APPLICATION FOR SUBMITTAL OF POST-APPROVAL DOCUMENT

2. PROJECT INFORMATION:			
School District/Owner: <u>Bakersfield City School District</u>		DSA File Number: <u>15 6</u>	
Project Name/School: <u>Dr. Martin Luther King Jr. Elementary School</u>		DSA Application Number <u>03 122605</u>

ADDENDUM NO. 2
PROJECT MANUAL
MLK ELEMENTARY SCHOOL
WELLNESS CENTER
BAKERSFIELD CITY SCHOOL DISTRICT

Project No.: 5527
DSA File No. 15-6
DSA App No. 03-122605
December 19, 2024

Sheet No.:
S6.01

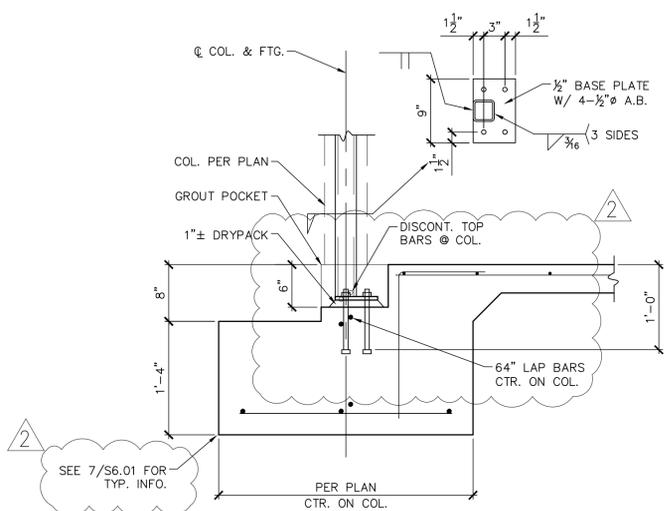
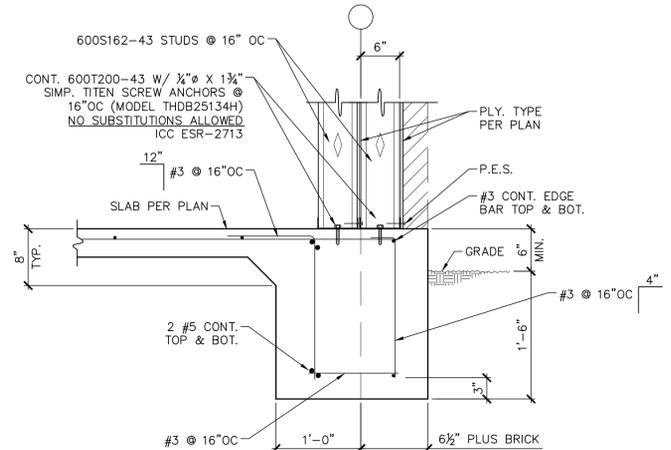
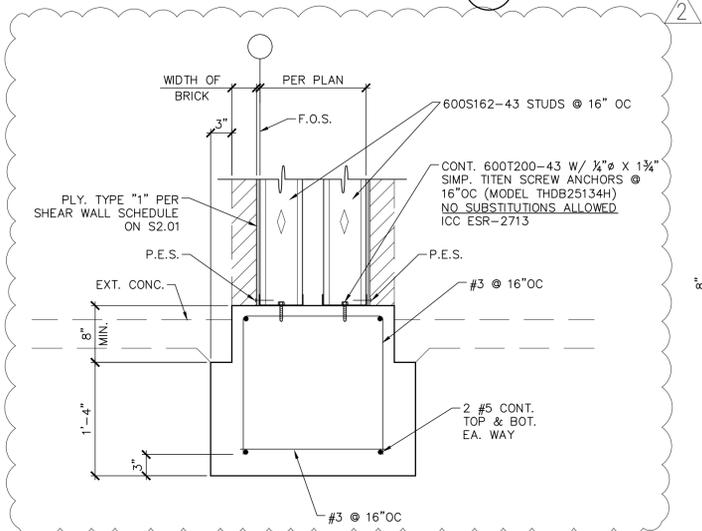
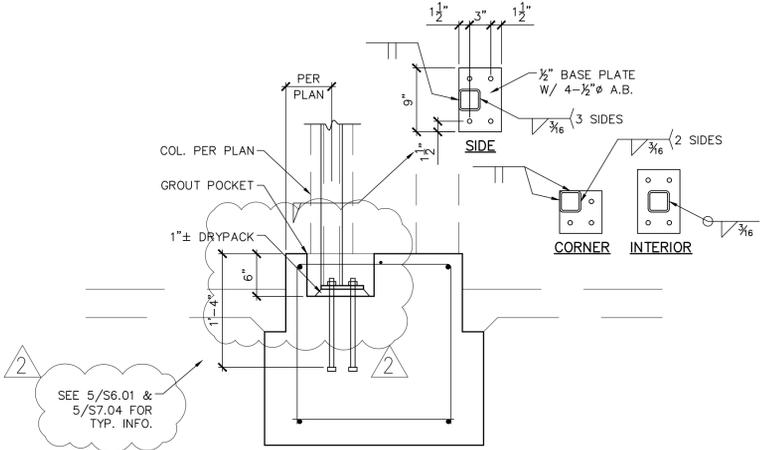
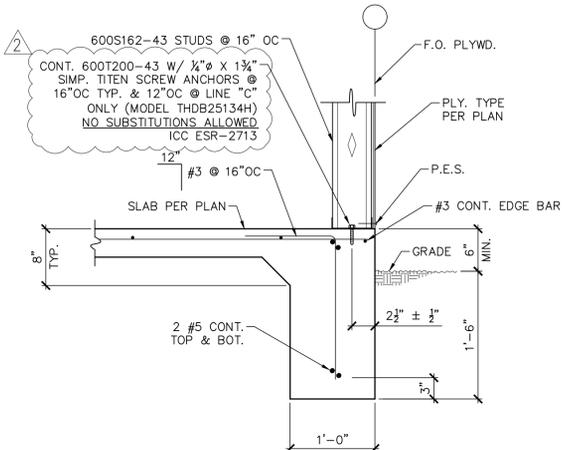
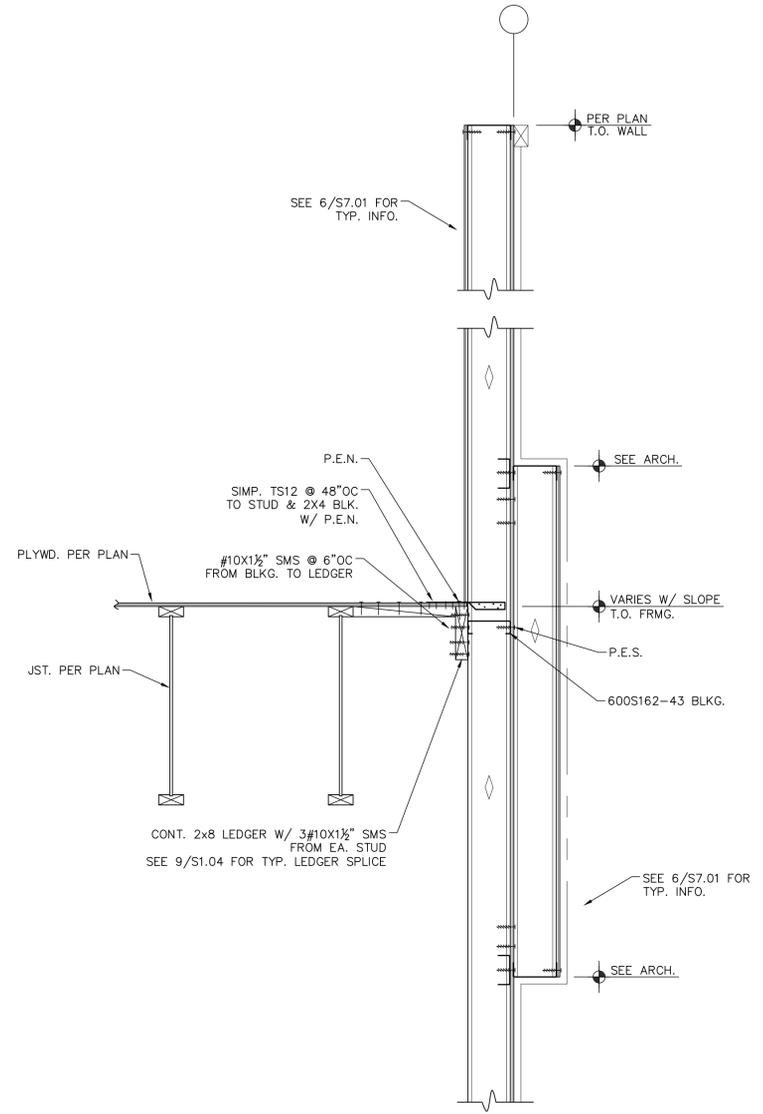
2-23 DRAWING, SHEET S6.01 – FOUNDATION DETAILS: Note the following changes (See S6.01 addendum 2 drawings):

1. Details 6, 7 and 8 the column pocket depth has been changed to 6".
2. Detail 5 concrete ledge has been added for the block veneer.

Sheet No.:
S7.02

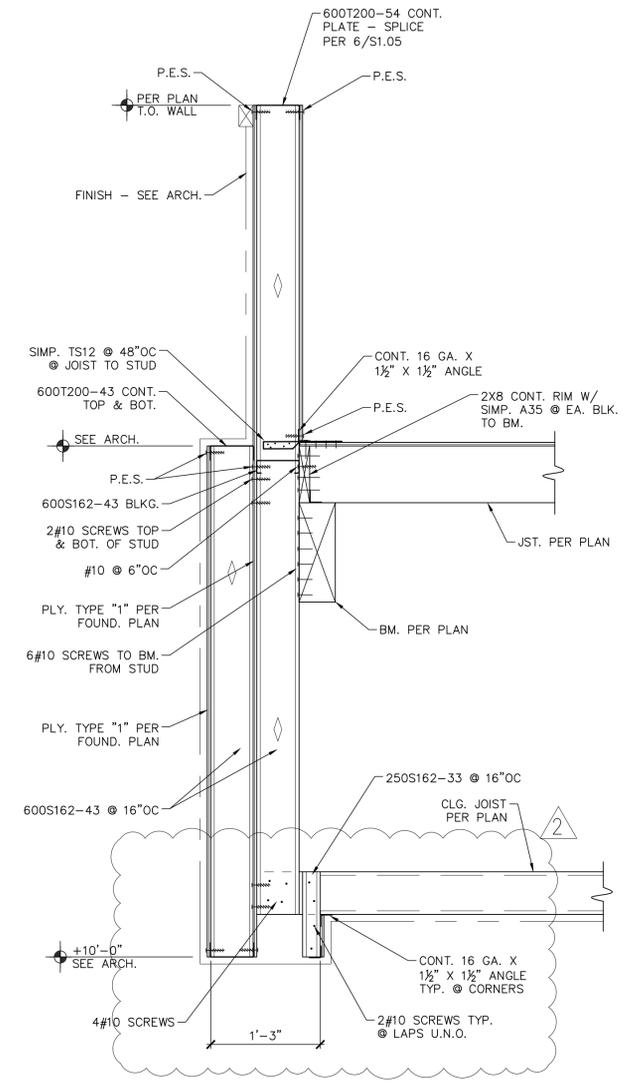
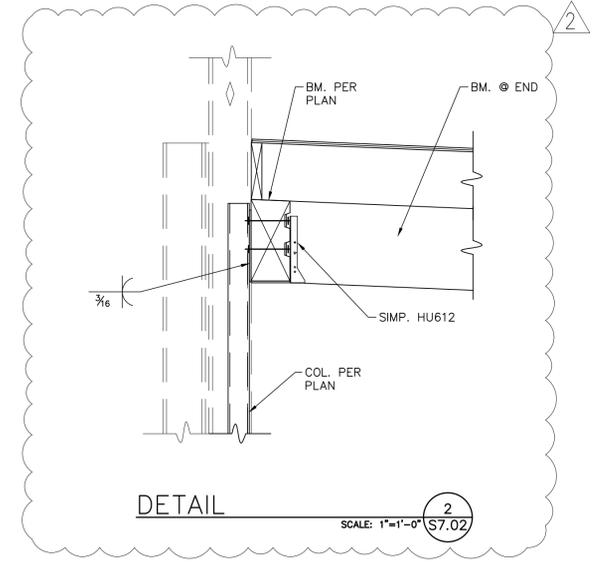
2-24 DRAWING, SHEET S7.02 – FRAMING DETAILS: Note the following changes (See S7.02 addendum 2 drawing):

1. Detail 2/S7.02 has been added.
2. Detail 1/S7.02 has been modified

Sheet No.:
S7.03

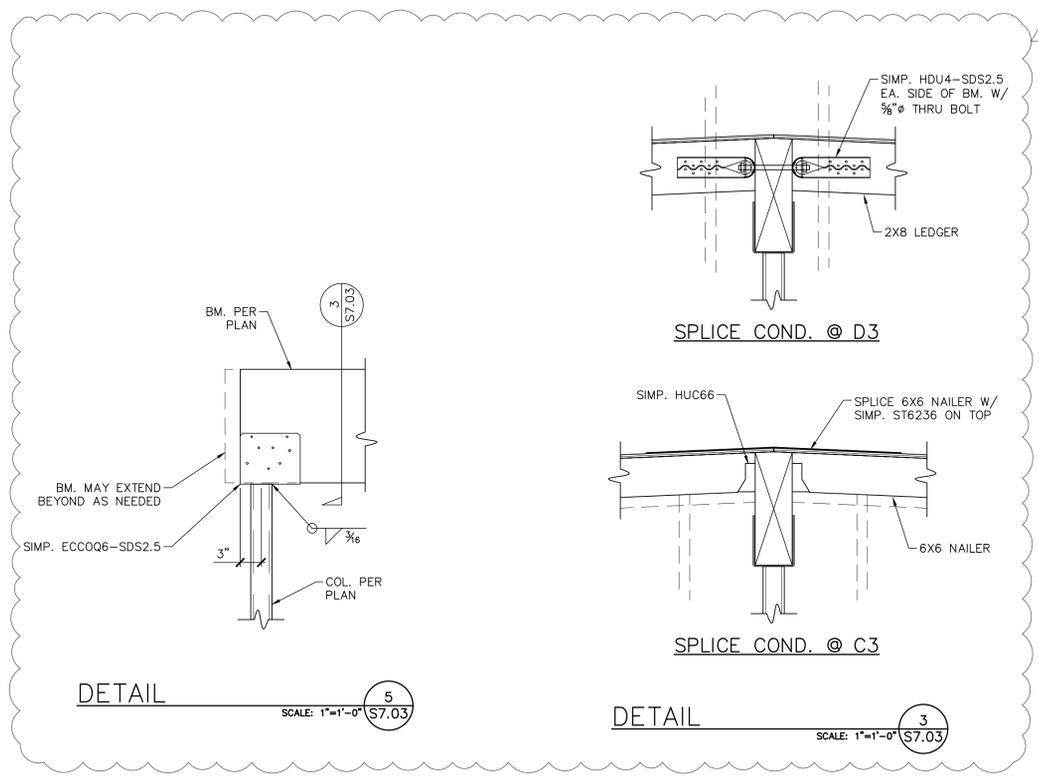
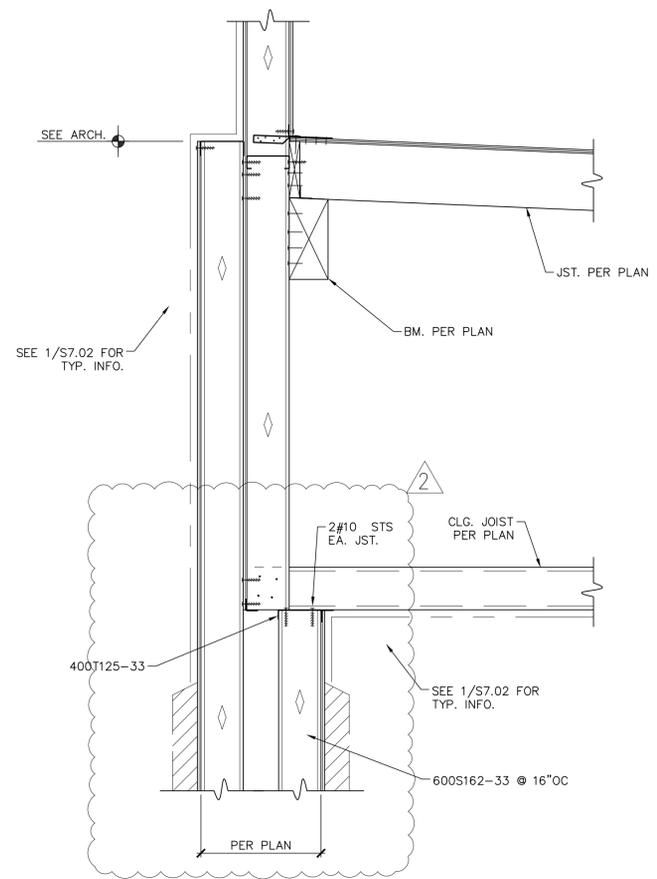
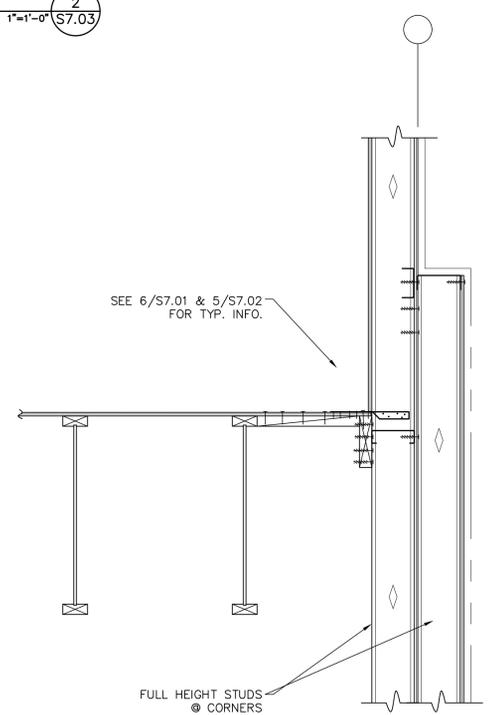
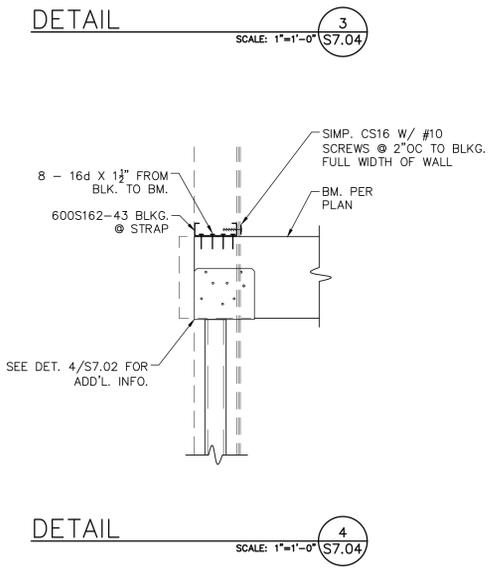
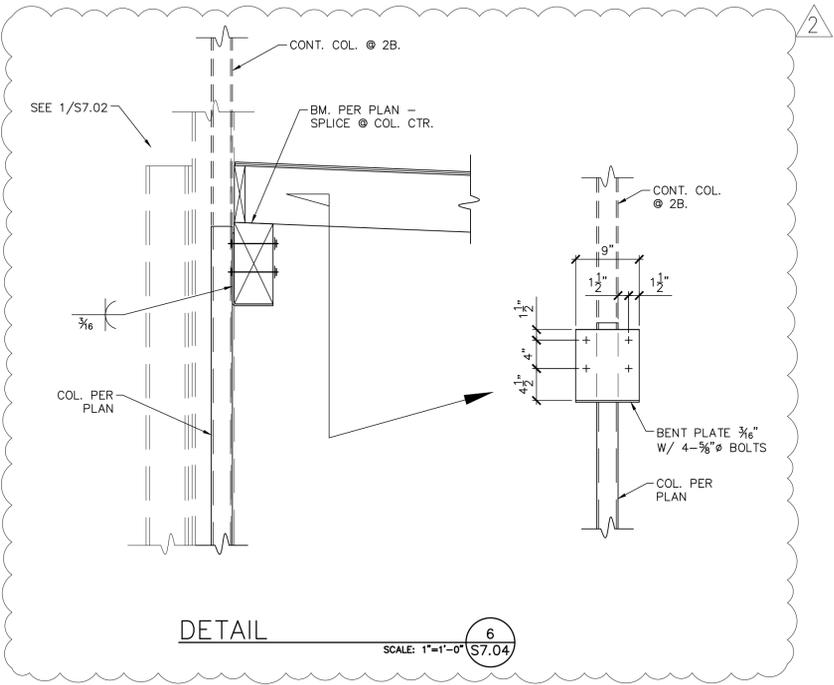
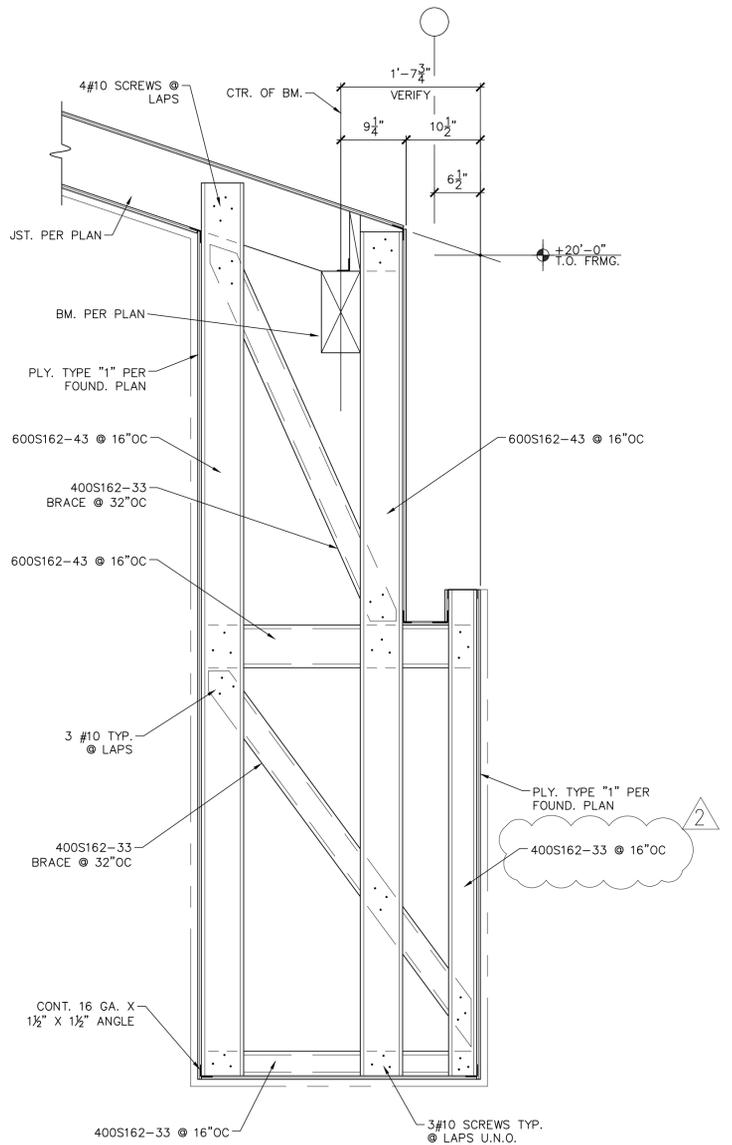
2-25 DRAWING, SHEET S7.03 – FRAMING DETAILS: Note the following changes (See detail S7.03 addendum 2 drawings):

1. Detail 2, 3 and 5/S7.03 have been modified.
2. Detail 4/S7.03 has been deleted.

Sheet Title:
DETAILS
Job No.: **5527**
Sheet No.: **M0.11**
Release: ADDENDUM 2
11/22/24

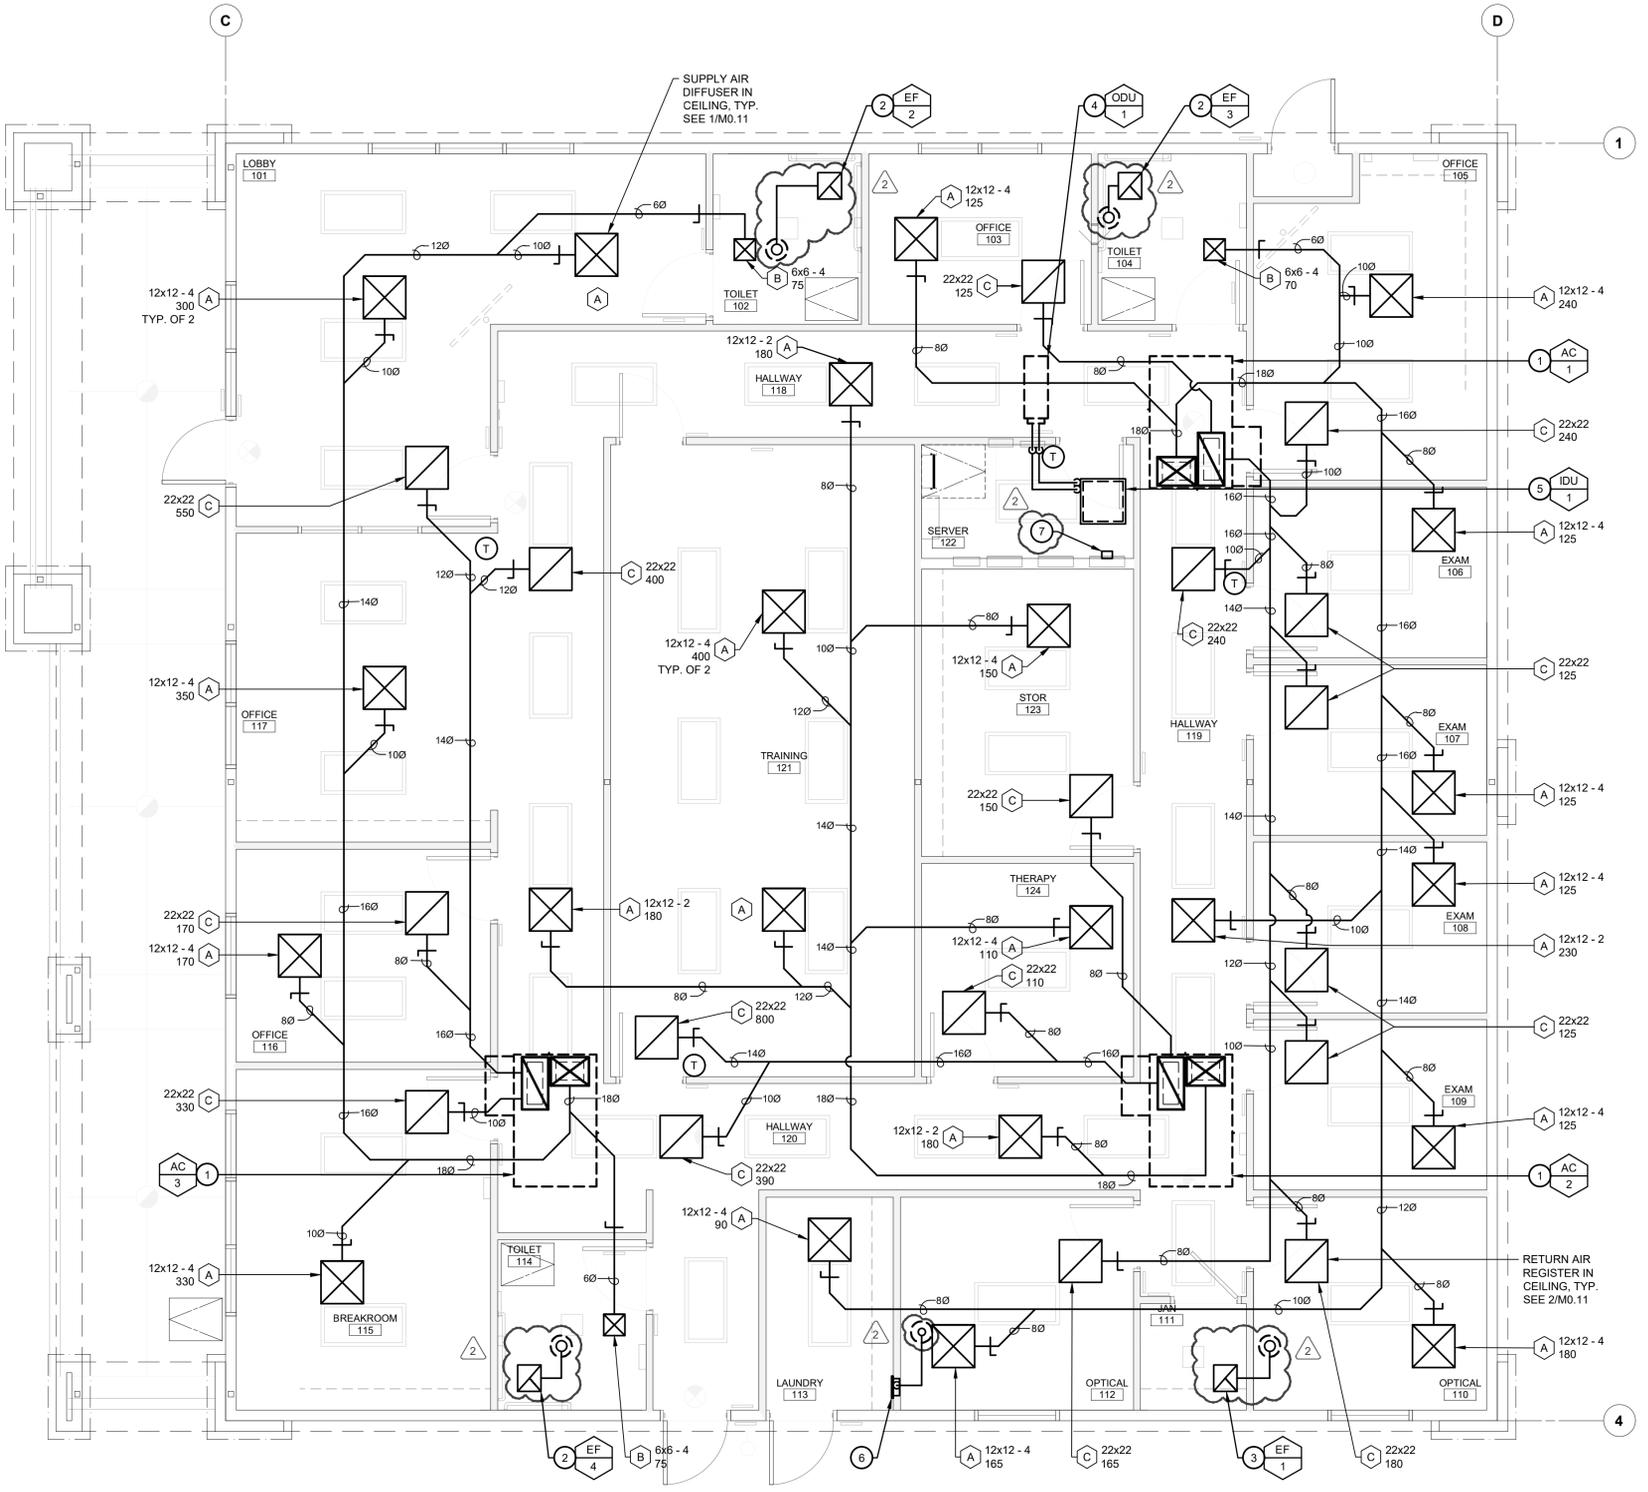
2-28 DRAWING, SHEET M0.11 – DETAILS: Note the following changes (See M0.11 addendum 2 drawing):

1. Add detail 8 and 14/M0.11 in their entirety.
